**Re: Hatchery Pit, DRMS File No. M-2014-043,
112 Construction Materials Reclamation Permit Application,
Fourth Adequacy Review**

Re: Third review of Slope Stability Analysis, Albert Frei & Sons Inc., Hatchery Pit, File No. M-2014-043

Project Albert Frei & Sons, Inc. - Hatchery Pit - M2014043
South Side

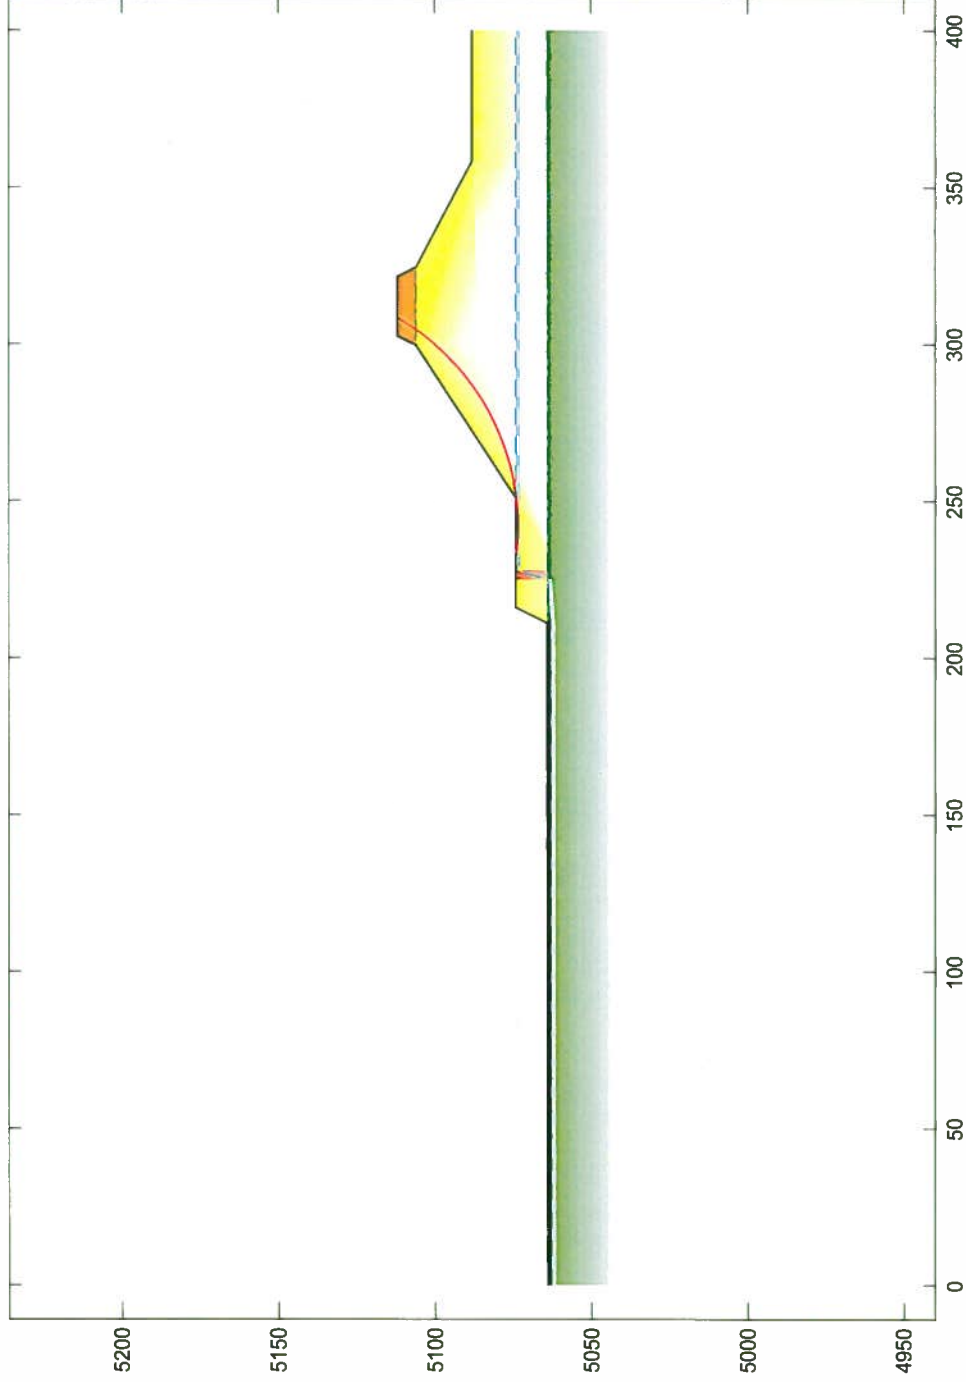
2. The Applicant's cross section was duplicated for verification. The safety factor produced by Galena is significantly lower (1.19) than the safety factor produced by the Applicant's model (1.3). Therefore, this slope configuration is unacceptable for the South Section cross-section. A copy of the Galena model is attached. The Division will require the Applicant to obtain structure agreements for all property, including easement holders, and structure owners within two hundred feet of the affected land for this cross-section. Alternatively, the Applicant may revise the model perimeters to increase the factor of safety to 1.3 or greater.

3. The Deere & Ault stability analysis model reversed the cross-section positions of overburden and sand & gravel and labeled the slurry wall as "Sand & Gravel". Please review the analysis model and revise the model as needed.

Project Albert Frei & Sons, Inc. - Hatchery Pit - M2014043
East Side

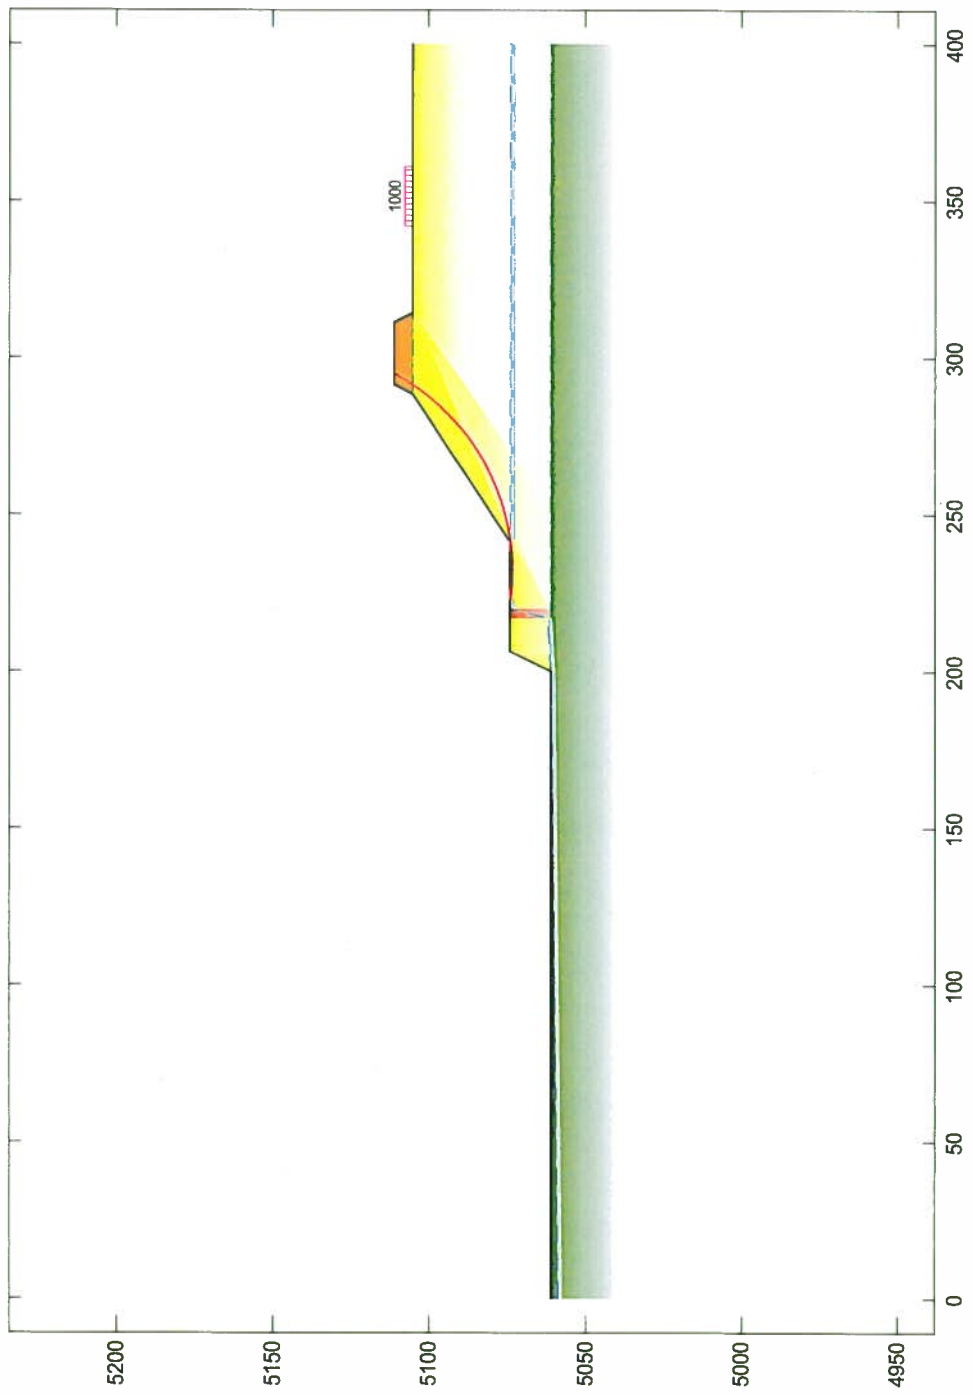
4. The Applicant's cross section was duplicated for verification. The safety factor produced by Galena is significantly lower (1.19) than the safety factor produced by the Applicant's model (1.3). Therefore, this slope configuration is unacceptable for the East Section cross-section. A copy of the Galena model is attached. The Division will require the Applicant to obtain structure agreements for all property, including easement holders, and structure owners within two hundred feet of the affected land for this cross-section. Alternatively, the Applicant may revise the model perimeters to increase the factor of safety to 1.3 or greater.
5. The Deere & Ault stability analysis model reversed the cross-section positions of overburden and sand & gravel. Please review the analysis model and revise the model as needed.

Project Albert Frei & Sons, Inc. - Hatchery Pit - M2014043

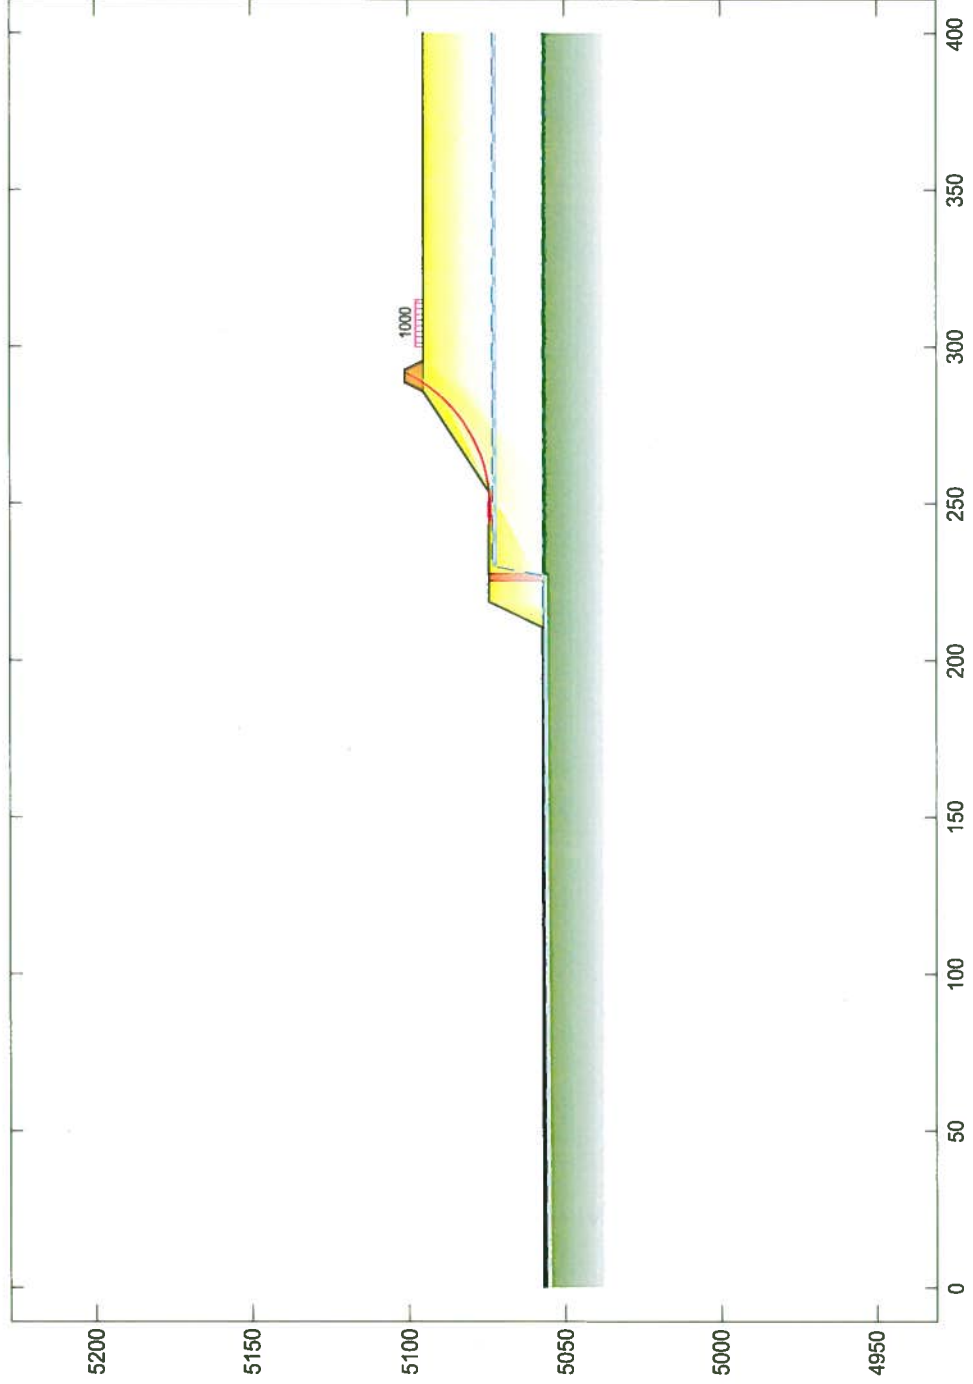
6. The Applicant's cross section was duplicated for verification. The safety factor produced by Galena is significantly lower (1.18) than the safety factor produced by the Applicant's model (1.3). Therefore, this slope configuration is unacceptable for the North Section cross-section. A copy of the Galena model is attached. The Division will require the Applicant to obtain structure agreements for all property, including easement holders, and structure owners within two hundred feet of the affected land for this cross-section. Alternatively, the Applicant may revise the model perimeters to increase the factor of safety to 1.3 or greater.
7. The Deere & Ault stability analysis model reversed the cross-section positions of overburden and sand & gravel and labeled the slurry wall as "Sand & Gravel". Please review the analysis model and revise the model as needed.

Project: Albert Frei & Sons, Inc. - Hatchery Pit - M2014043
Phase 1

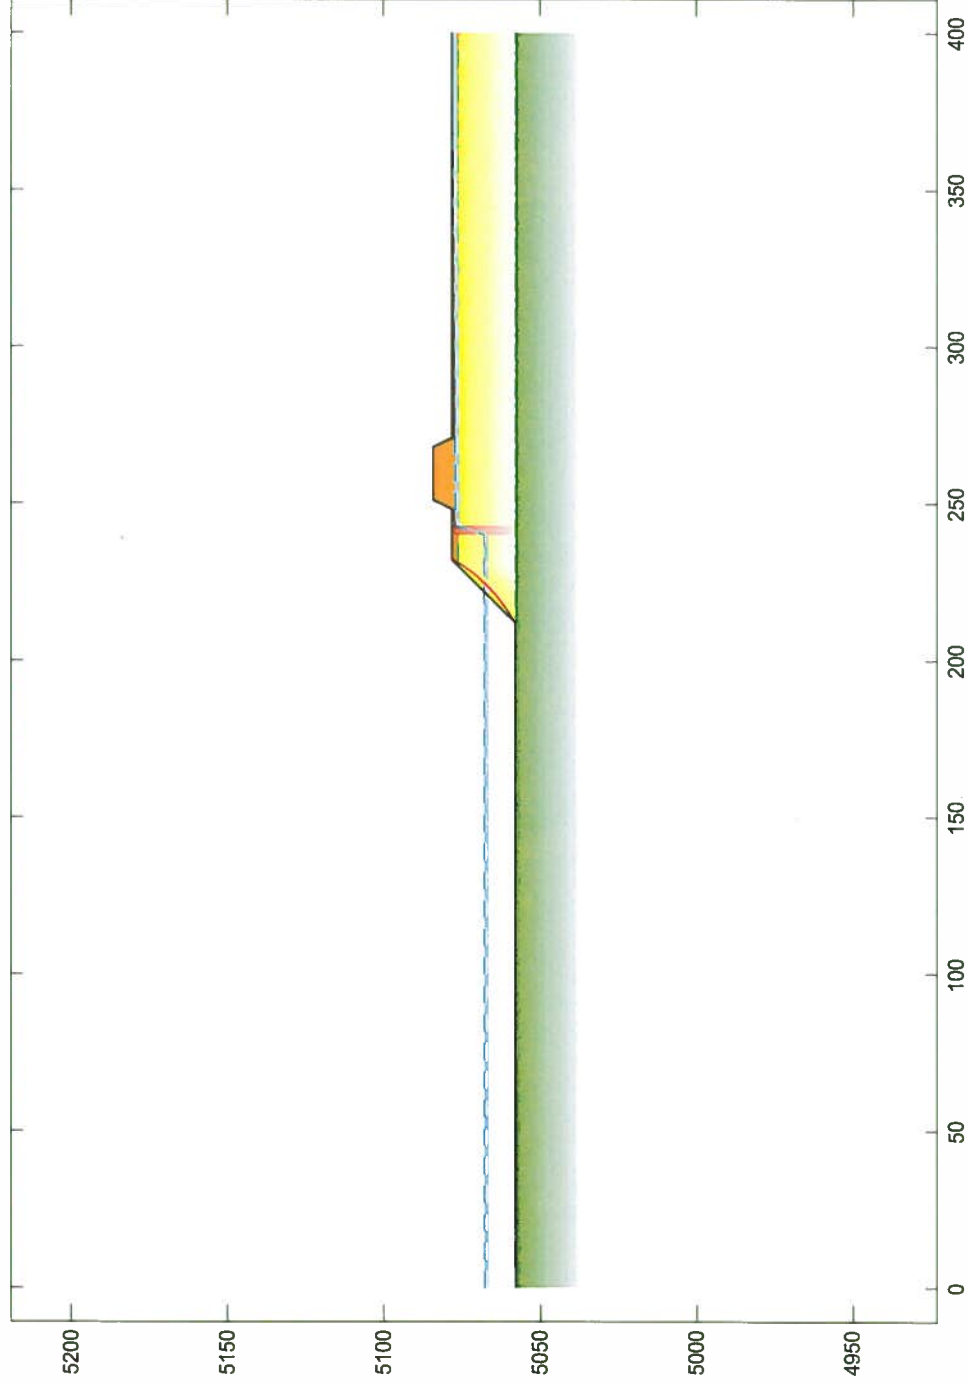
8. The Applicant's cross section was duplicated for verification. The safety factor produced by Galena is significantly lower (0.74) than the safety factor produced by the Applicant's model (1.3). Therefore, this slope configuration is unacceptable for the Phase 1 Section cross-section. A copy of the Galena model is attached. The Division will require the Applicant to obtain structure agreements for all property, including easement holders, and structure owners within two hundred feet of the affected land for this cross-section. Alternatively, the Applicant may revise the model perimeters to increase the factor of safety to 1.3 or greater.

9. The Deere & Ault stability analysis model reversed the cross-section positions of overburden and sand & gravel. Please review the analysis model and revise the model as needed.
